# Service Bulletin

## SAFETY RECALL

### 2003 ST1300/A Wire Harness Inspection and Repair

**ST1300/A #2  
DECEMBER 2004**

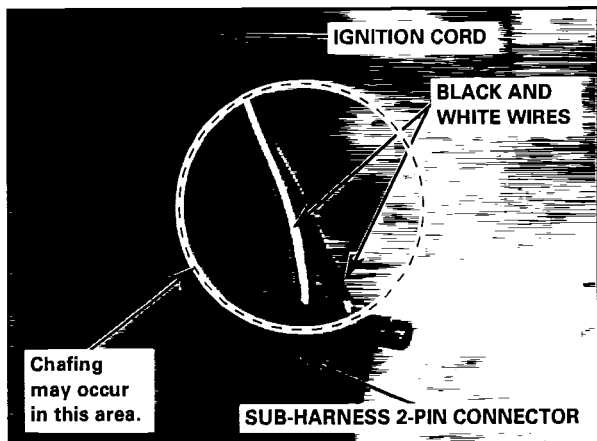
5. Locate the ignition cord leading to the 2P connector and check the two black and white wires for chafing.

- If the insulation is still intact and copper wire is not showing, proceed to the *Preventative Measure* section of this bulletin.
- If copper wire is showing, wrap the exposed area of the wire with a good quality electrical tape and proceed to the *Preventative Measure* section of this bulletin.

**Preventative Measure:**

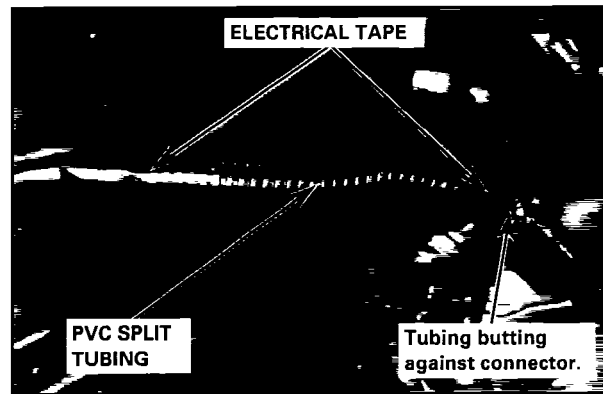
1. Place the length of PVC split tubing around the ignition cord, butting up against the connector. Rotate the split toward the inside of the motorcycle.

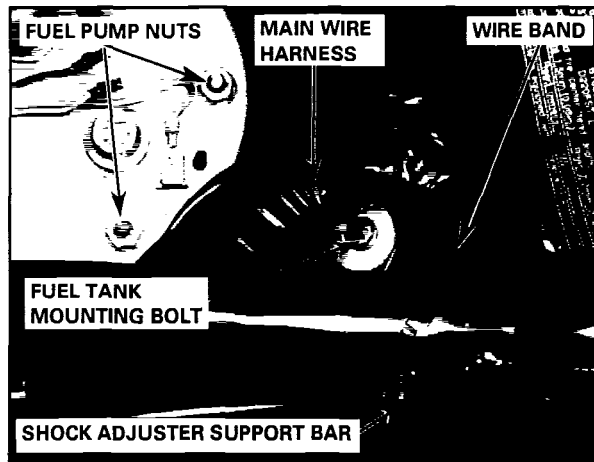
2. Use good quality electrical tape to cinch the end of the PVC split tubing together (at the end that is touching the 2-pin connector), together. Secure the PVC split tubing to the ignition cord at the other end with electrical tape.
3. Secure the ignition cord and wire harness cord to the rear sub-frame with a commercially available wire band. The 2-pin connector should be routed behind and to the rear of where the rear shock adjuster support bar is located.

4. Reinstall the rear shock adjuster support bar. Insert the bar into the slot in the rear sub-fender, and install and tighten the top bolt.
5. Check that the rear main wire harness wire band is in place and in the correct location. The harness must clear the fuel pump nuts and fuel tank mounting bolt.

## IDENTIFICATION

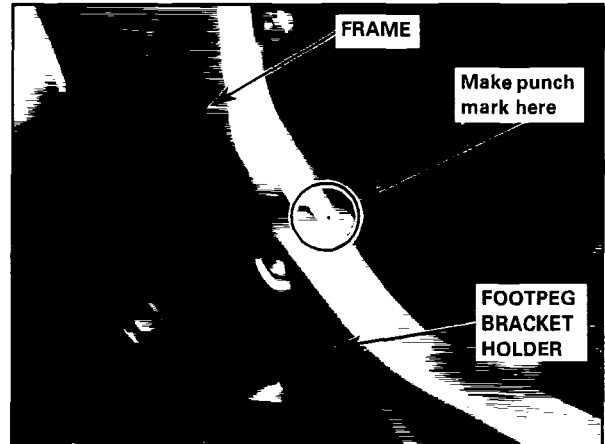
Make a punch mark on the left side of the frame, on the inside and above the forward upper footpeg bracket holder.
